Well Name: DOGWOOD 25 36 20 FED COM	Well Location: T25S / R36E / SEC 20 / SWSE / 32.109156 / -103.2843617	County or Parish/State: LEA / NM
Well Number: 115H	Type of Well: OIL WELL	Allottee or Tribe Name:
Lease Number: NMNM138912	Unit or CA Name:	Unit or CA Number:
US Well Number: 3002552140	Operator: MATADOR PRODUCTION COMPANY

Sundry ID: 2841682

Type of Action: APD Change

Procedure Description: Matador respectfully requests the option to make the following changes to the DOGWOOD 25 36 20 FED COM 115H. Update Well and Casing Design. Details can be found in the attached Drill Plan with updated casing, cement and drilling fluid information. SHL change from O-20-25S-36E; 200' FSL and 1780' FEL to O-20-25S-36E 140' FSL and 1890' FEL. The new SHL remains on the existing drill pad. BHL change from B-17-25S-36E; 50' FNL and 2260' FEL to A-17-25S-36E 110' FNL and 660' FEL Proposed TVD 11,450'

4-String Wellhead Diagram

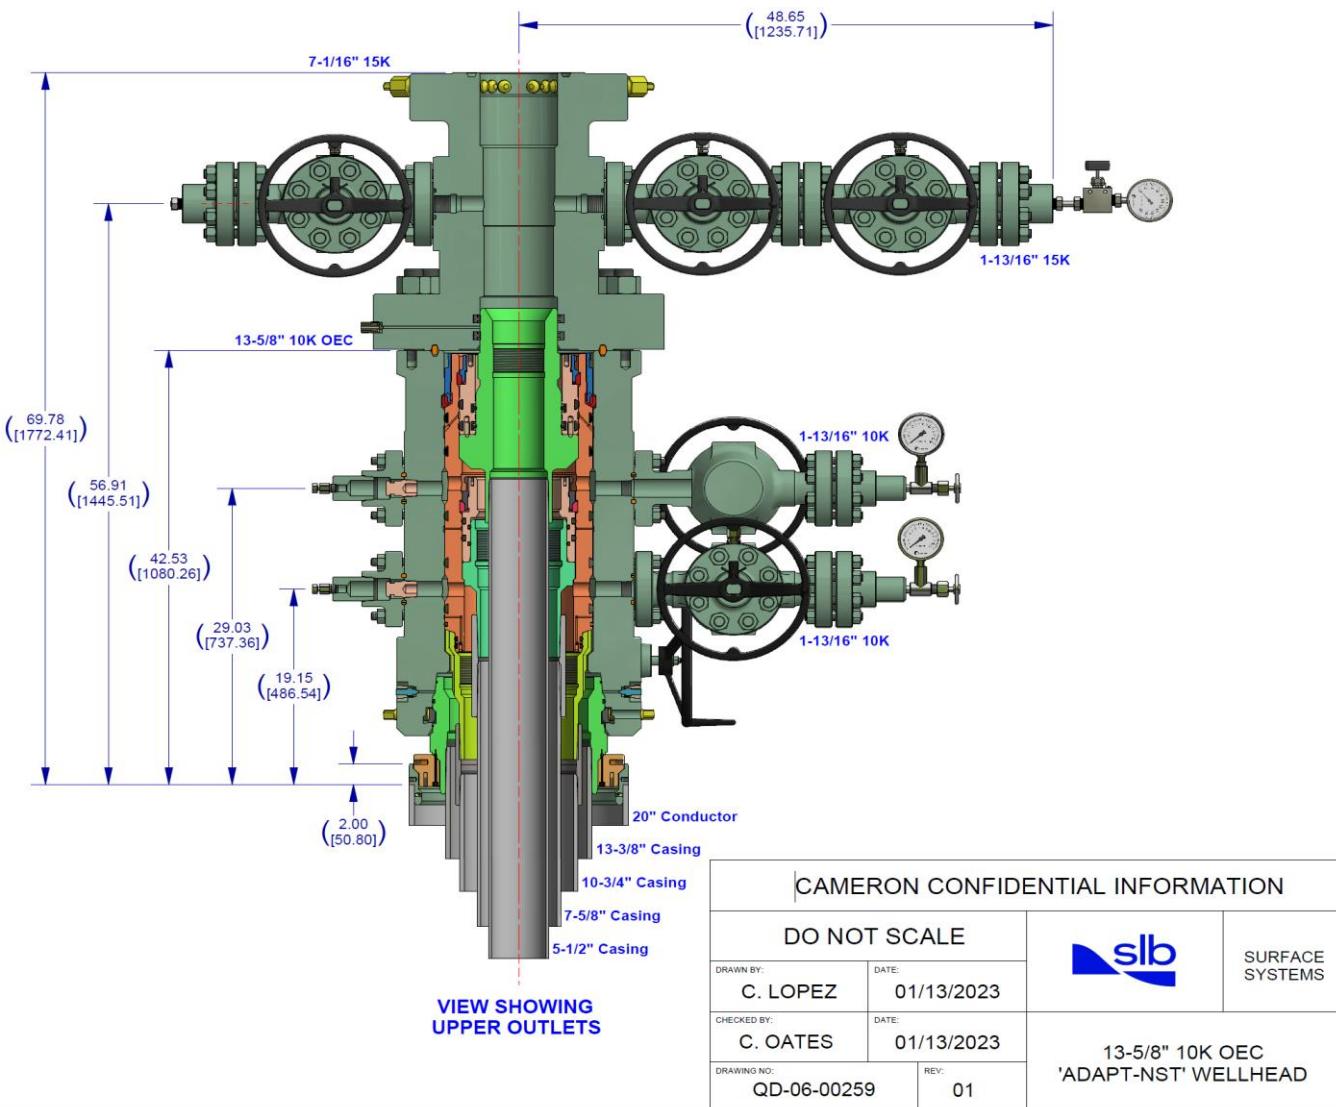
Matador request option to switch to Design B (4 string) if losses are observed in Capitan Reef. If losses are observed, an additional intermediate casing string will be ran to isolate losses. No other changes in well design are required. The 10-3/4" SC casing spec sheet along with 4-string wellhead diagram are attached.
